The Ridges at Deer Lake Phase III

Eastern Connecticut Environmental Review Team Report

Environmental Review Team Report

**for the
Planning and Zoning Commission
Killingworth, Connecticut**

Figure 3.
Lot Layout

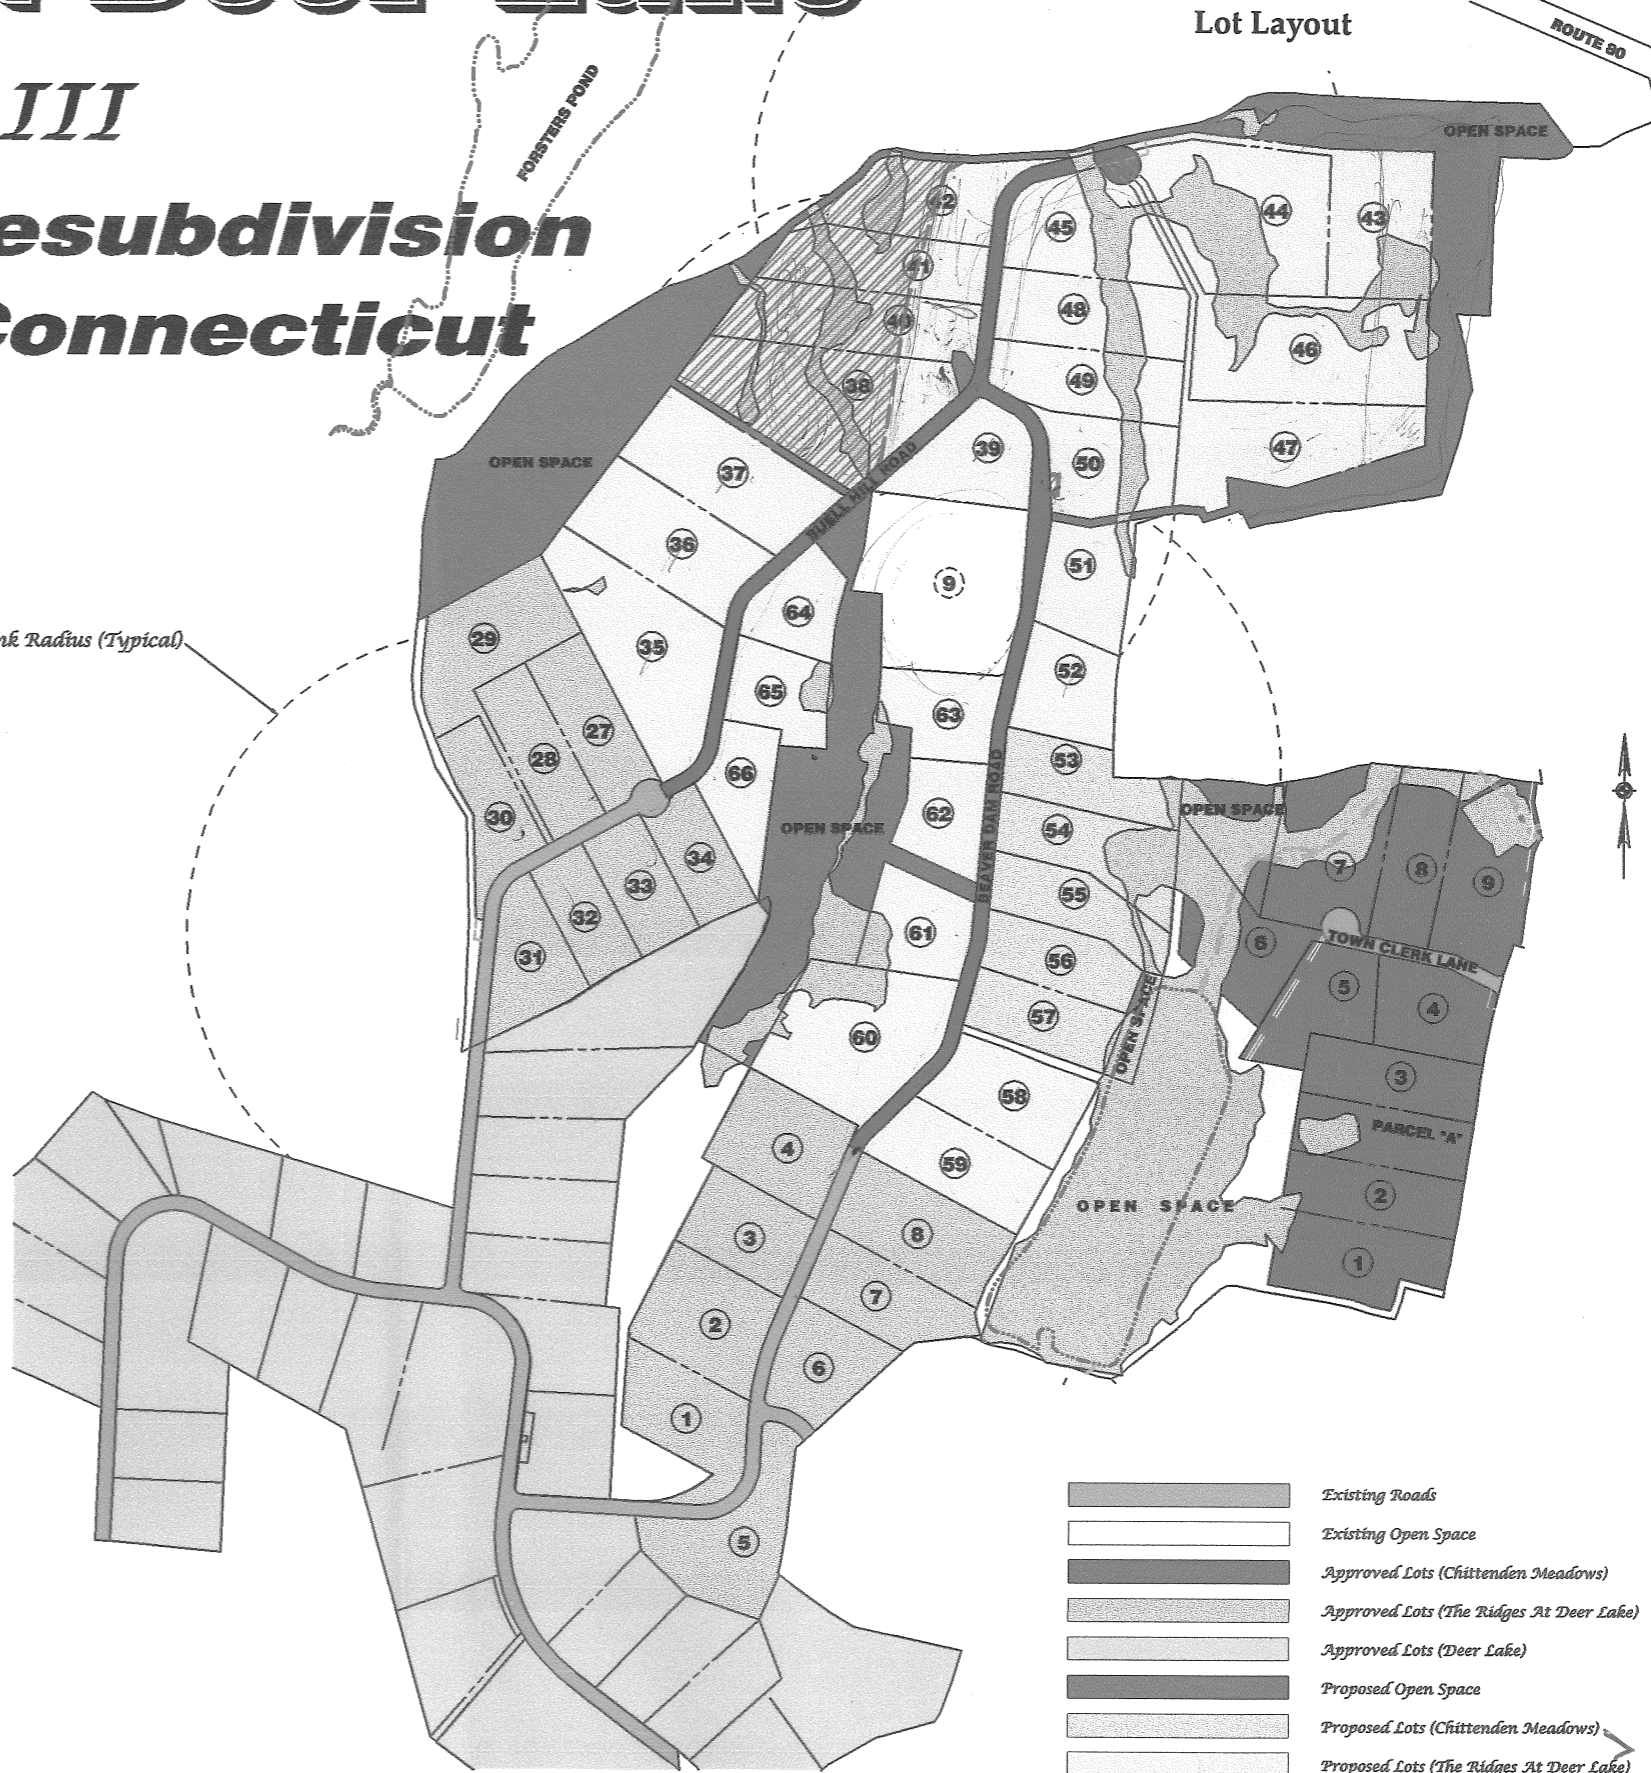
1. Verify the presence of watercourse(s) within the wetland area for lots 45, 48, 49, and 50. All watercourses should be shown on the plans.
2. Clarify the methodology for calculating minimum buildable area when a watercourse is present. For lots 45, 48, 49, and 50, verify that the minimum buildable lot area calculations are correct, meet the contiguous soil definitions, and that lots have <25 percent wetland soils.

1. Request installation of antitracking pads for individual lots when house construction begins.
2. Request that road diversions are incorporated into the erosion and sediment control plan especially for the road segments with 8 percent or greater grade. Request that driveway diversions are incorporated into the erosion and sediment control plan especially for driveways longer than 100 feet and/or with a slope greater than 5 percent.

3. As each lot is developed, ensure that adequate erosion and sediment control measures are installed and maintained especially for lots with:
 - driveways immediately adjacent to wetlands (lots 43, 44, 46, and 47)

- steep and/or long driveways (lots 35-44, 46-47, 49-57, 59, 63, and 66)
4. On lot 46, silt fencing is shown running up the slope. Silt fencing should run parallel to slope contours. Consider replacing the hay bales with stone check dams. The stone check dams will last longer, remain in place, and help filter sediment from stormwater. Also, consider placing a water bar across the road at the curve near the staked hay bales. The water bar will divert and prevent water from concentrating and eroding the driveway.

- The Typical Lot Soil Erosion and Sediment Control Plan should be modified to specify the installation of antitracking pads on driveways.
- A detail of the grassed swale and level spreader shown on Lot 46 must be included.
